Focused Review of Specific Remediation Issues

An Addendum to the Remediation System Evaluation
for the
Homestake Mining Company (Grants) Superfund Site, New Mexico

Final Report
December 23, 2010

Prepared by US Army Corps of Engineers
Environmental and Munitions Center of Expertise
For US Environmental Protection Agency, Region 6

Figure 21.

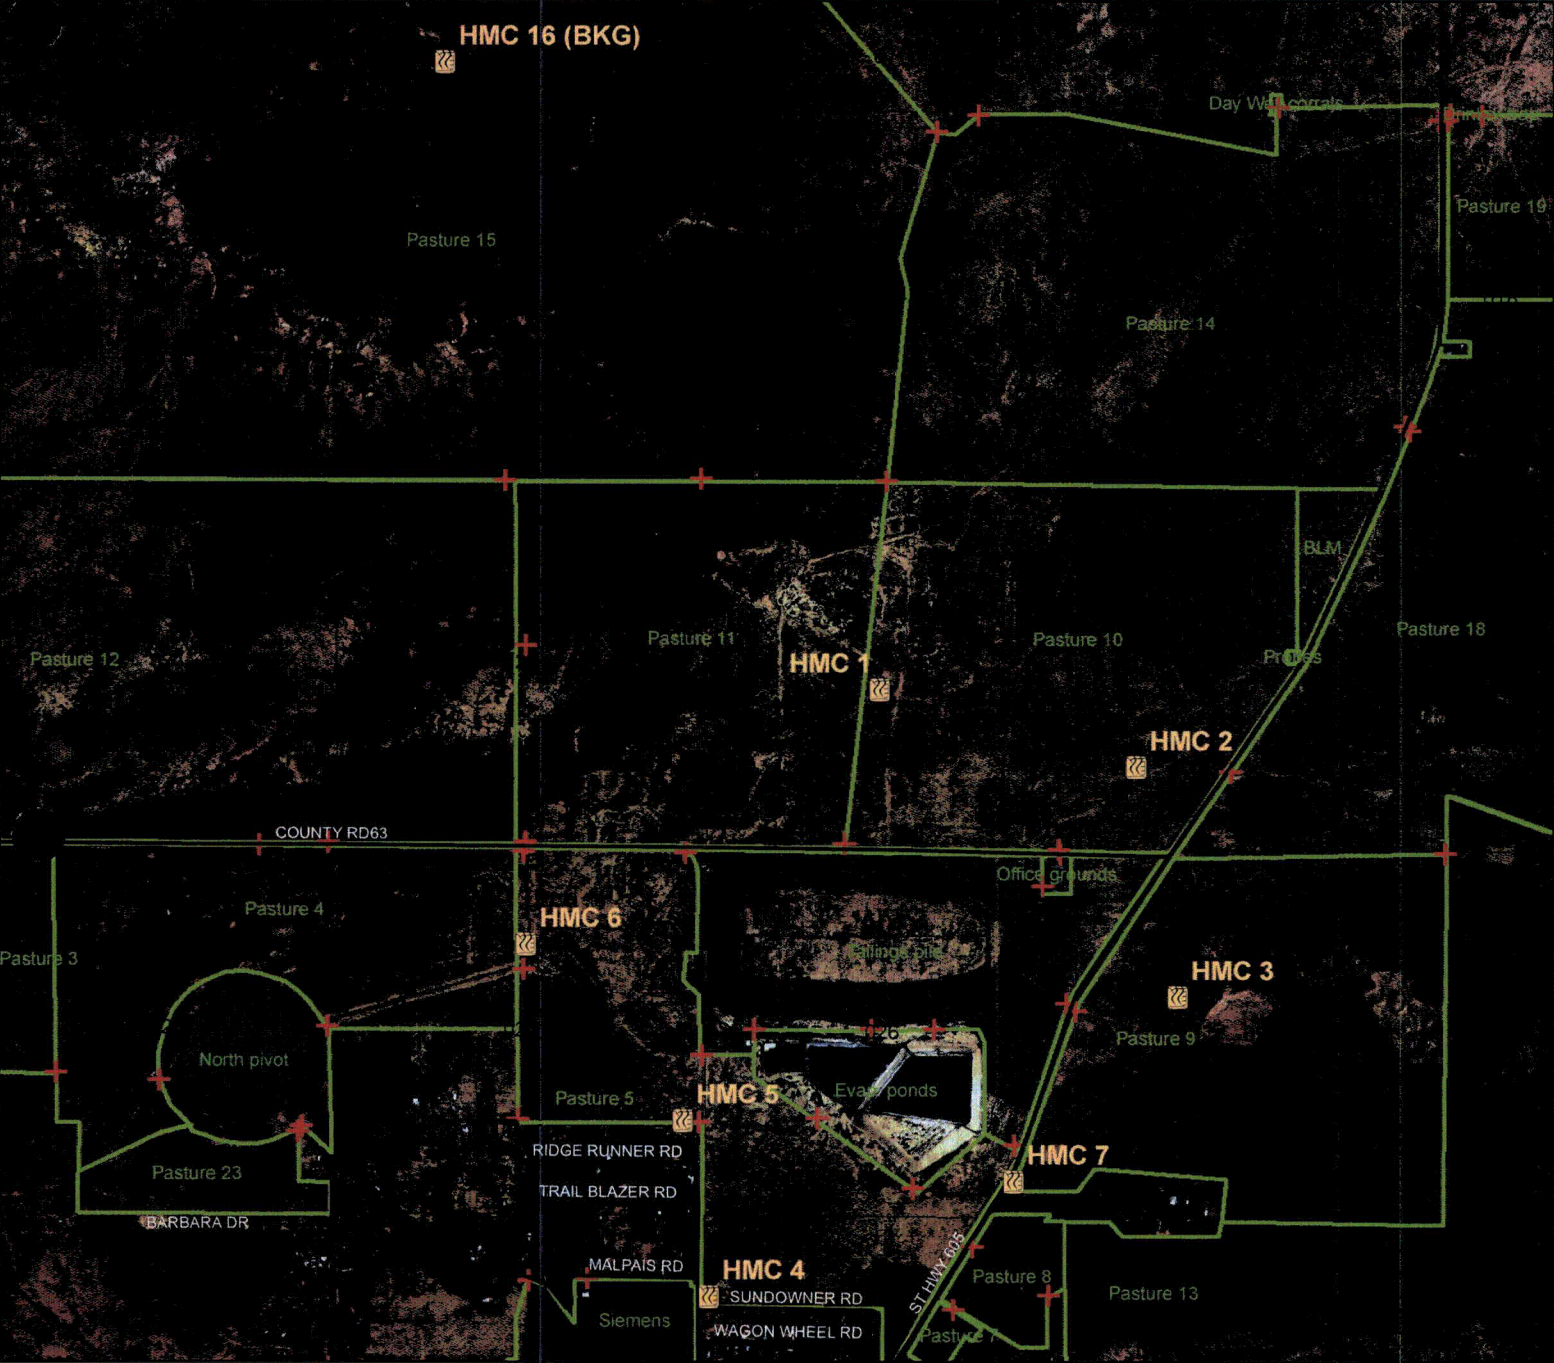
¹ DRSE Figure 21 is a copy of a map that HMC has used many reports for at least the last decade, but which is now known to be incorrect with respect to the location of HMC #16. The more recent figure that is reproduced as Figure 1 in this report not only is stated to be accurate with respect to the location of HMC #16 (see, testimony of Kenneth L. Baker, January 12, 2010 (HMC, 2010; Exhibit 36B)), but is also more legible.
